Unit 4 Walls, Trim & Outlets

Room-by-room wall treatment, trim moulding and outlet plan. One section per room with site photos, wall mock-ups and a usability check of every outlet.

WORKING PLAN — not a cut, purchase or electrical release. Written dimensions govern; do not scale drawings. All heights in inches above finished floor (AFF).

L01 · plain wall shared with bedroom Working proposal exact R2 set-out

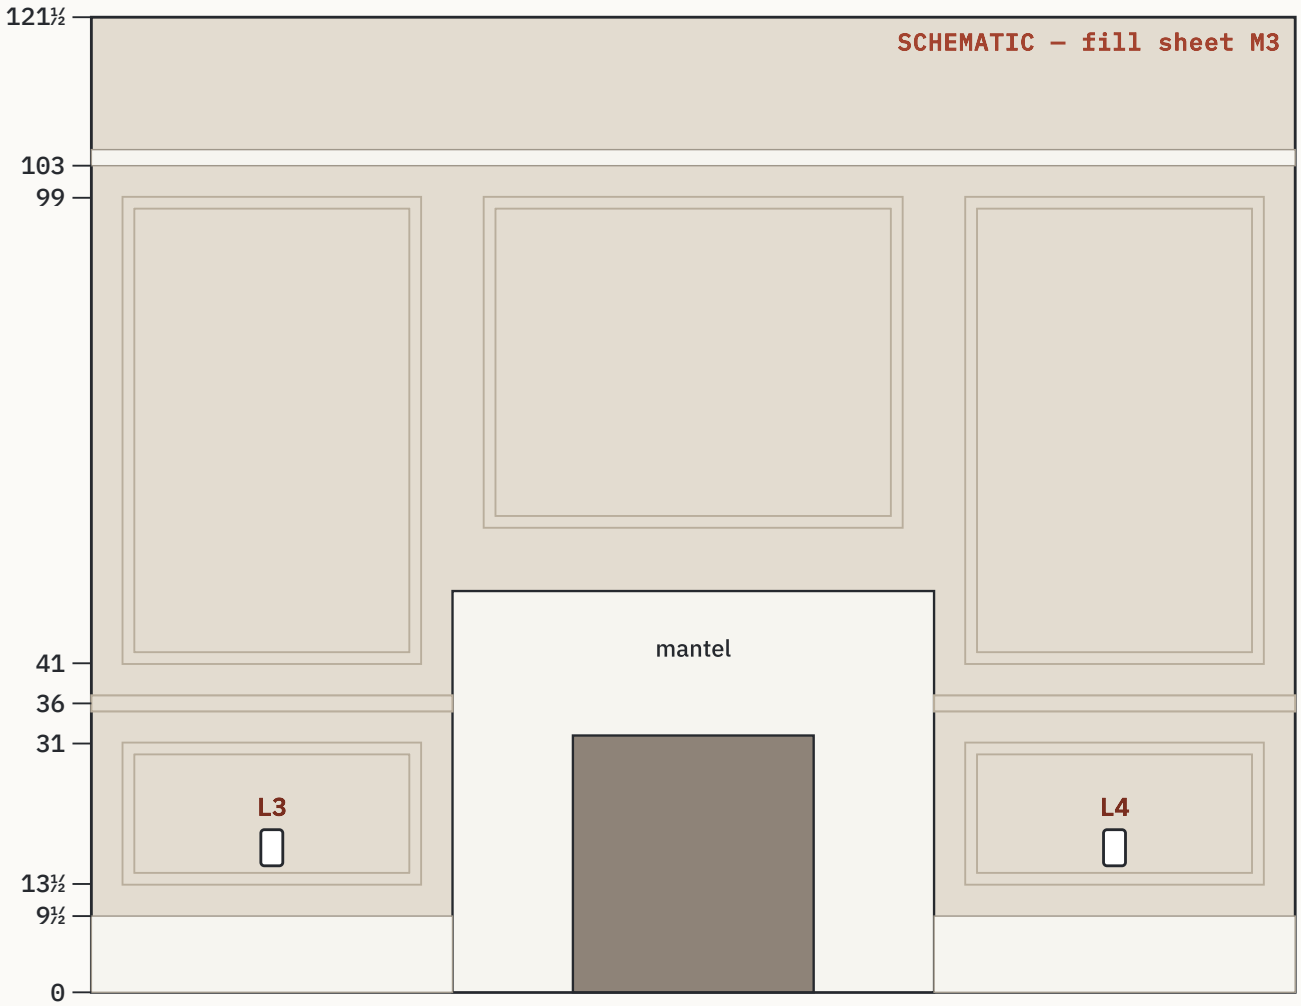
- **Two outlets per wall, not three (Tisa, 2 Nov).** L01 gets only L1 and L2; the optional centre TV outlet is dropped. Coverage still passes: the farthest point from an outlet is 44½ in, inside the 6-ft rule.

- **Frames on pocket piers:** fix with adhesive and short brads only — nothing that could reach the pocket or the door track.
- **Switch by the L01 door:** stays where it is, outside U1 and lower frame 1.

L03 · south fireplace wall Working proposal five frames; mantel and services hold

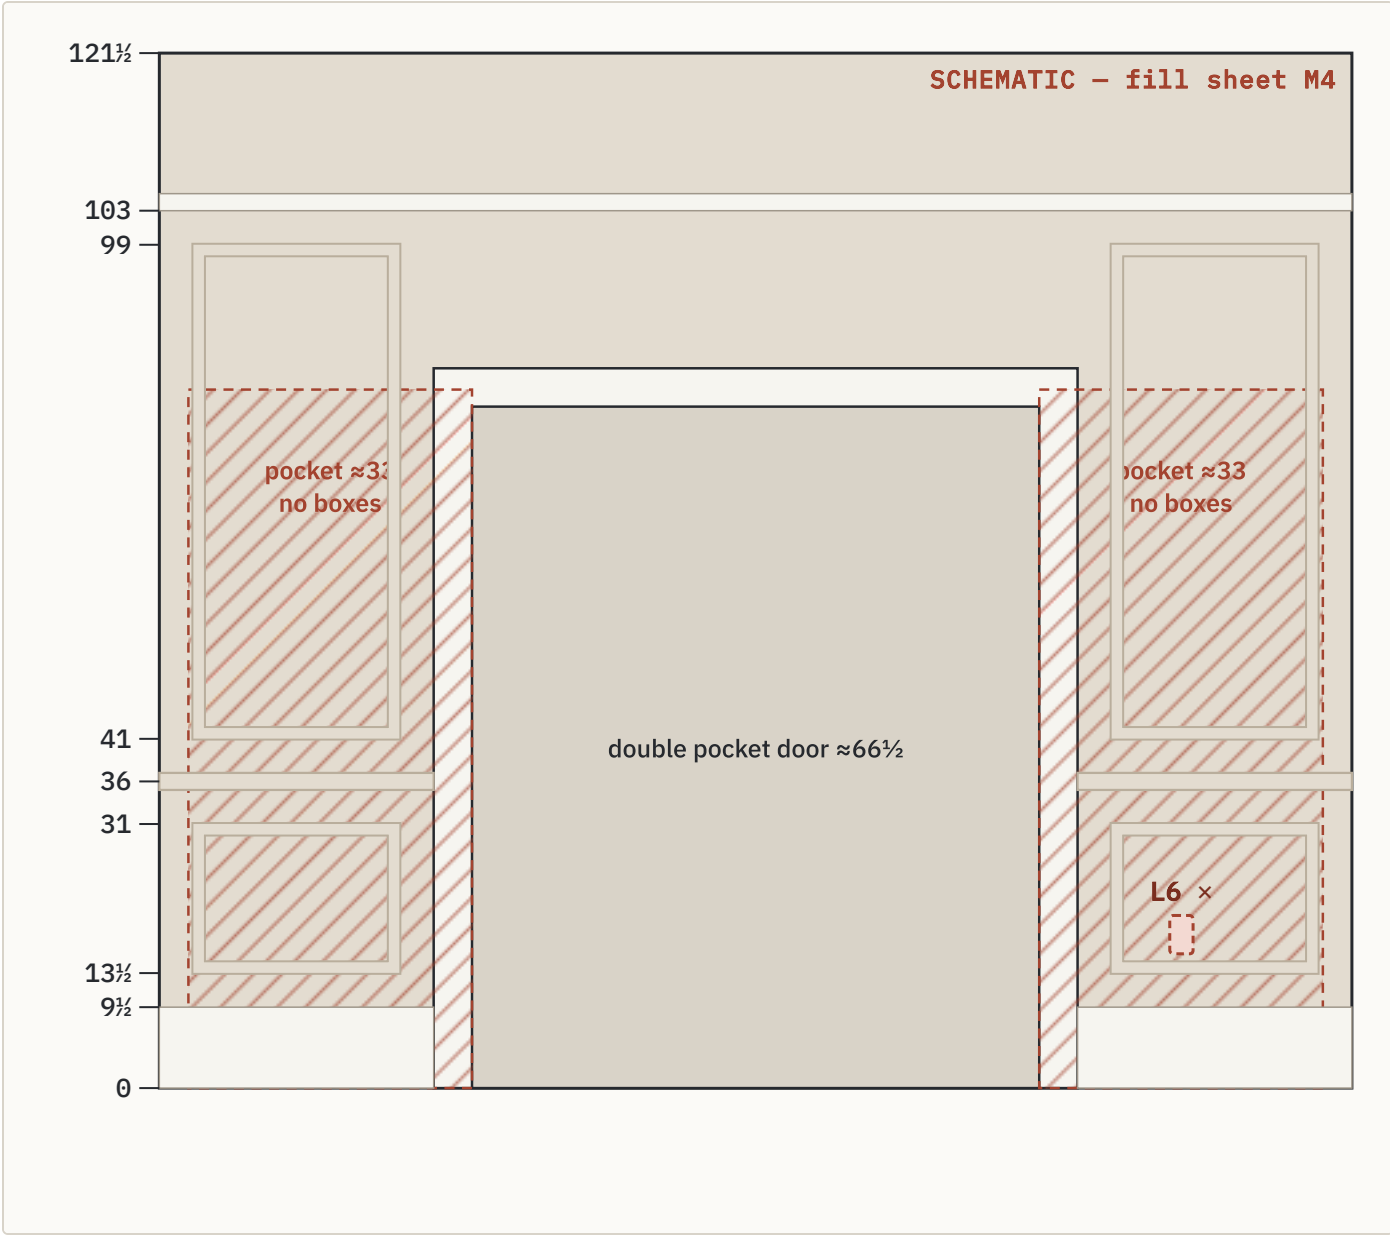
- **Fireplace wall:** no TV above the mantel in this plan (heat, viewing height). L3/L4 serve side-table lamps; the pipe/conduit strip in IMG_0453 must be resolved before any box or frame fixing.

D02 · south wall — freestanding buffet New suggestion two equal bays, same rule as D01 and D04

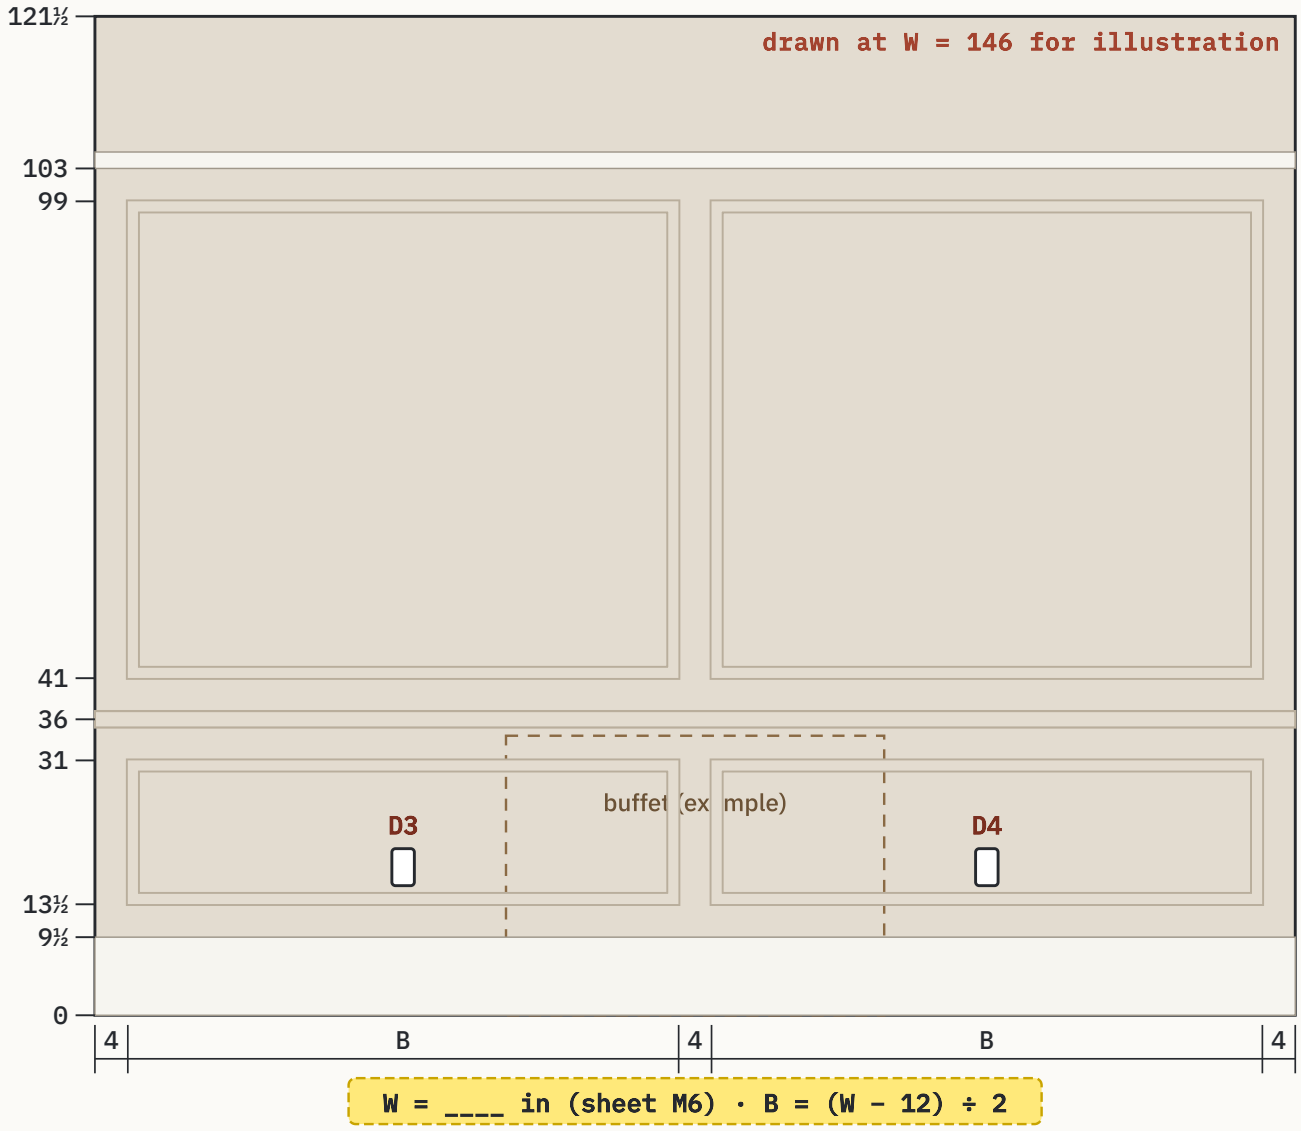
- **The dining buffet is freestanding and movable** (Tisa, 2 Nov; it has already been moved). So D02 no longer wraps a built-in: it gets the same two equal bays as D01 and D04, installed in full even where furniture stands in front, and D3/D4 sit in the two lower frames wherever the buffet ends up. R2's raised centre frame, headpiece and cabinet-return questions no longer apply. Owner-confirmed

D03 · east pocket face toward living Electrical — decided D6 cannot sit in the pocket

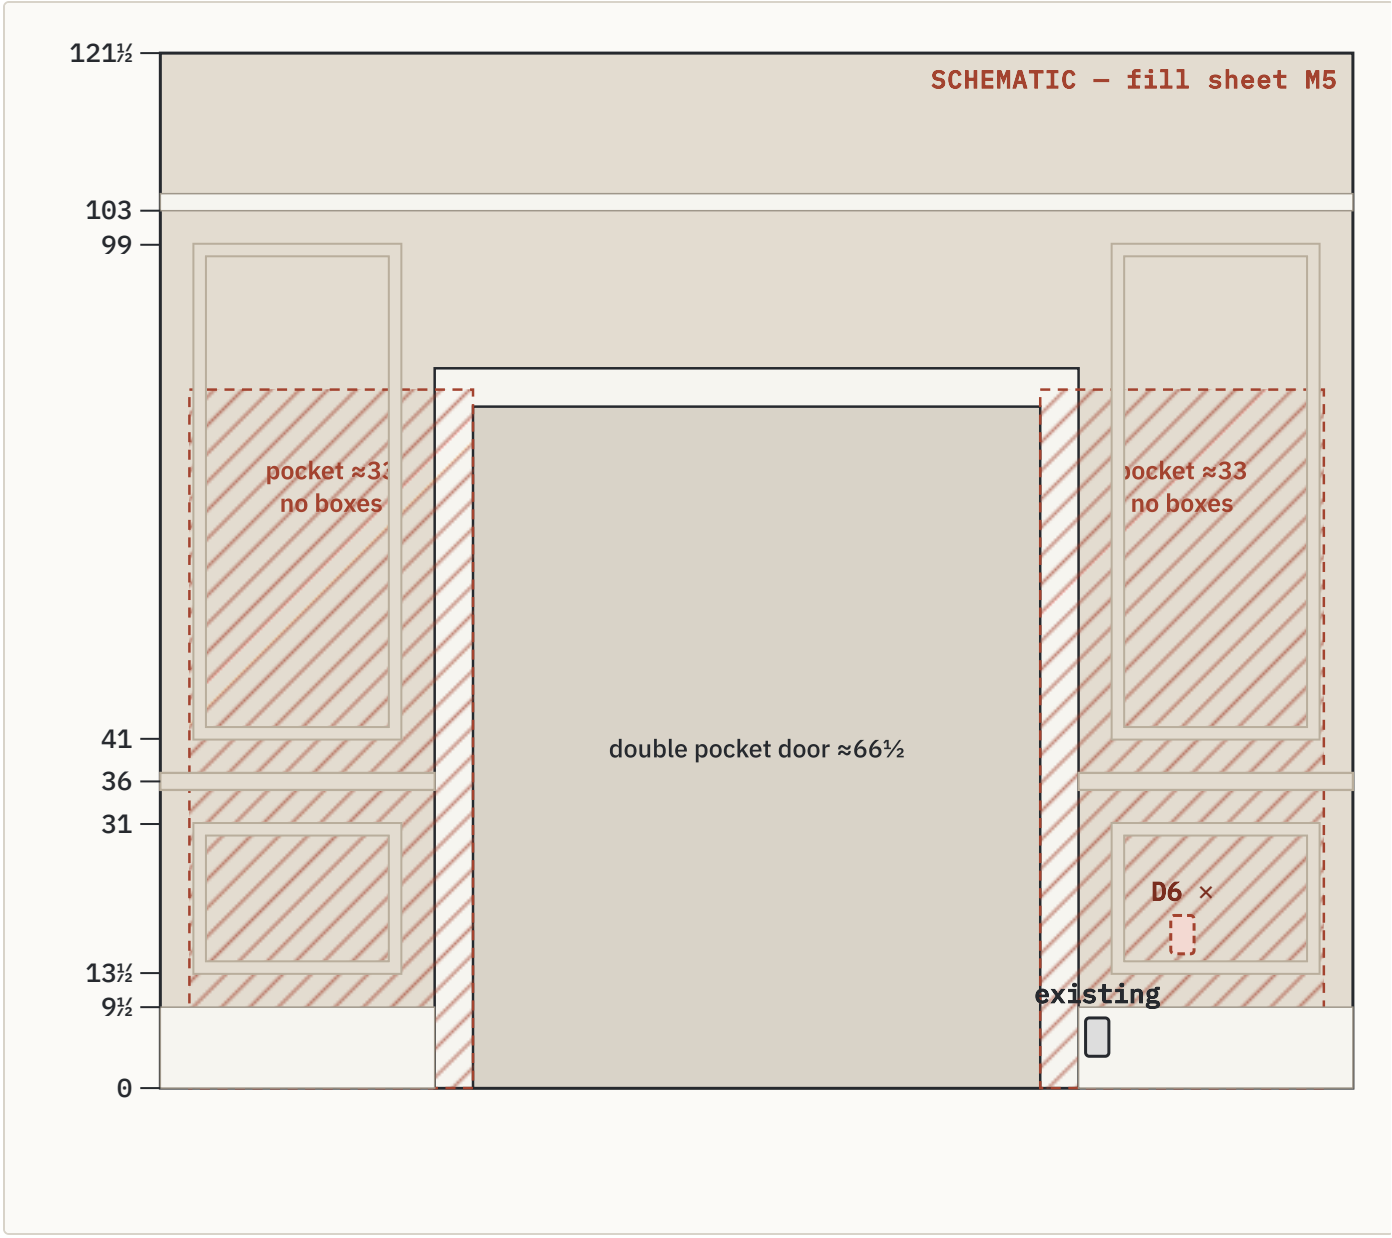
- **Pocket piers (L6):** each leaf of the ≈66½-in double pocket door is ≈33 in, so roughly 33 in of wall beside each opening is hollow pocket. A box fits only past that. If the pier is under ≈37 in wide, drop L6 and let L1 cover that corner.

D04 · west window and infill wall — subpanel Working proposal panel centre x = W/4 + 1, 65 AFF

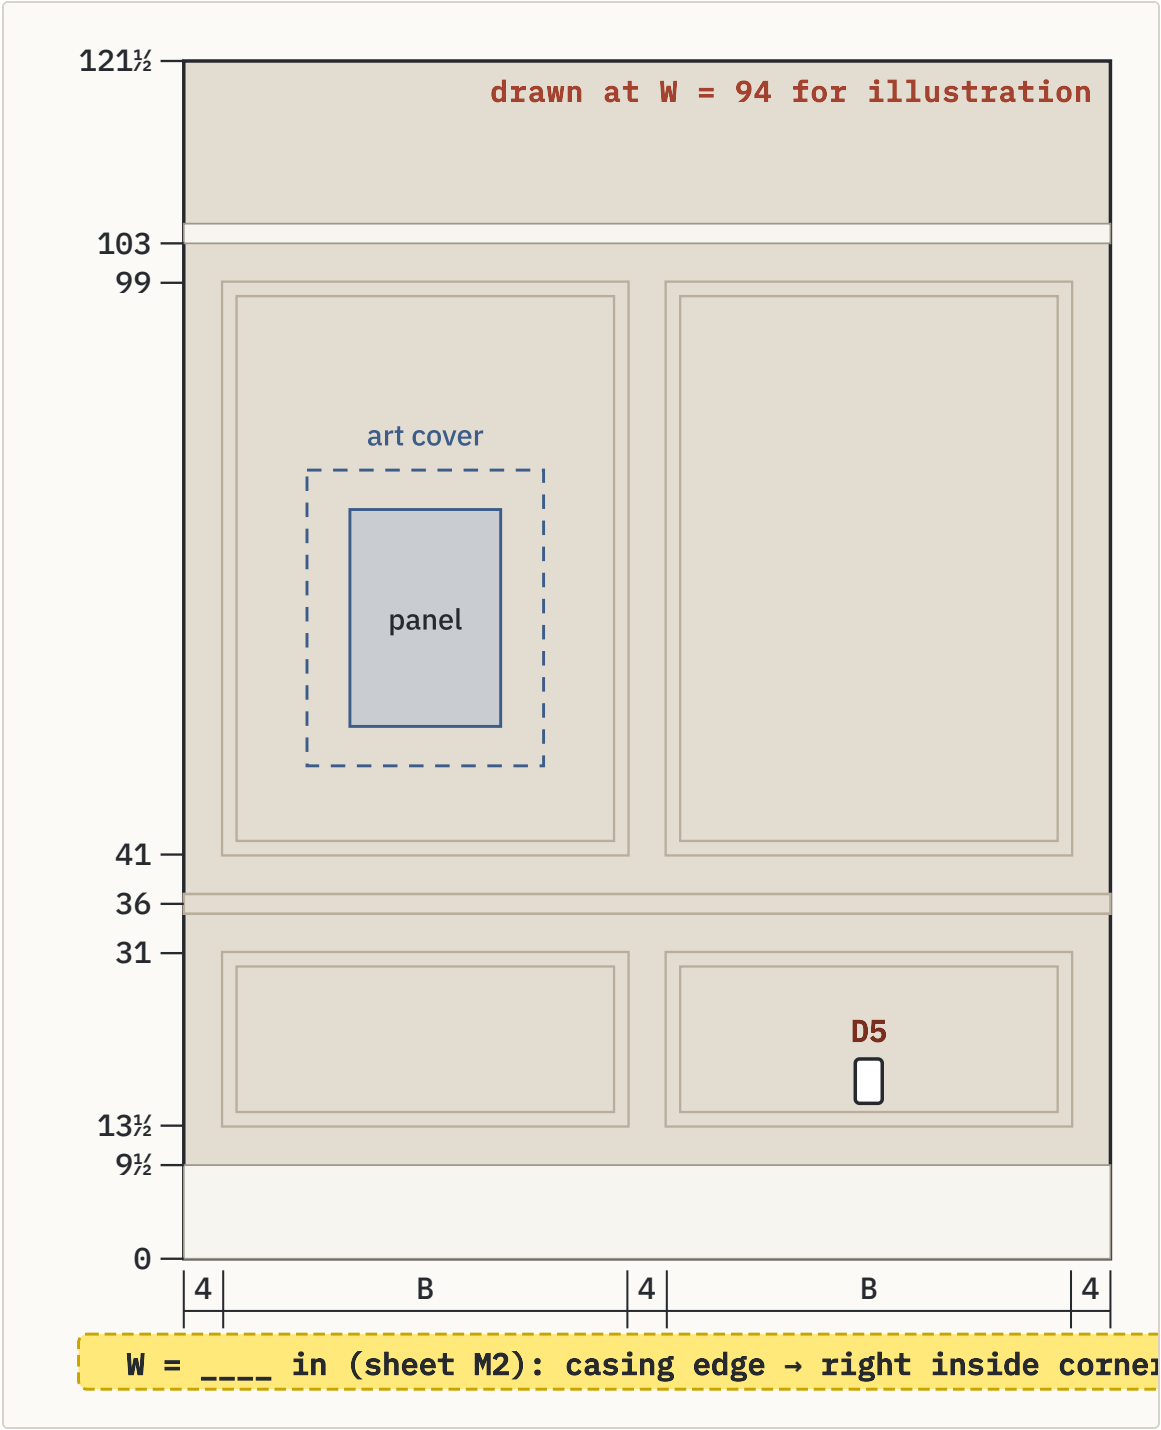
- **D5 moved to the right bay (suggestion):** the subpanel and its art cover sit in the left upper bay. Putting D5 under the right bay keeps cords away from the panel's working space and the hinged cover.

- **Panel fit:** at W = 94 the left upper opening is 38½ × 55½; the BRPX2A20L1F cover (15.3 × 22) fits with room for an art cover. Final position waits for the can and cover in hand (D04 framing package).

Wall B · shared with living room Owner-confirmed Rev B, 2 Nov — three equal tall bays, 31 / 43 / 31

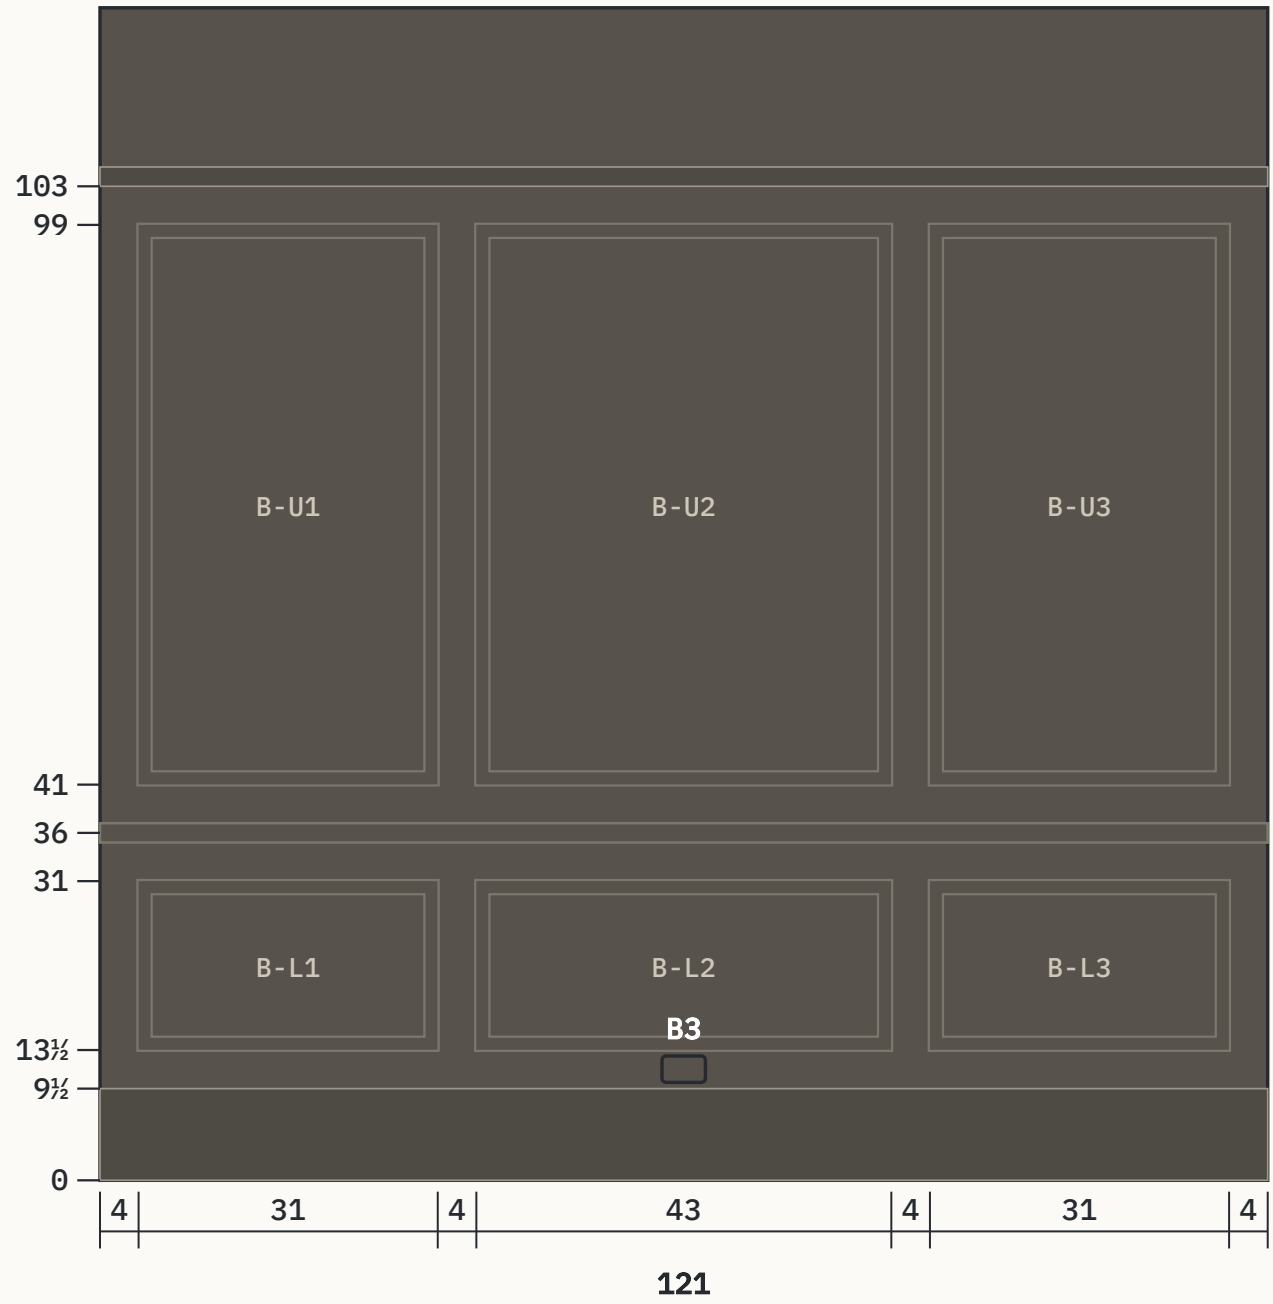
- **Bedside reach passes.** With the packet's example queen bed centred at 62, the side tables span 7–27 and 97–117. B1 (17) and B2 (107) land at the centre of each table — reachable, not hidden behind the headboard.
- **Plate fit passes.** A horizontal plate at 11½ spans 10⅛–12⅞, clearing the baseboard (9½) and frame bottoms (13½) by ⅝ in each.
- **Coverage passes** on A (17 in to each end of the run, 90 in between) and B (60½ to each end).

- **Count differs between sources:** the packet places 3 outlets; the Oct 27 whole-unit plan budgets 5 (adds a desk spot and a bay-wall spot). If the extra two are kept, use the same dark horizontal plate at 11½.
- **Device colour:** the bedroom uses dark devices and covers (packet). The whole-unit plan's white devices apply outside the bedroom.
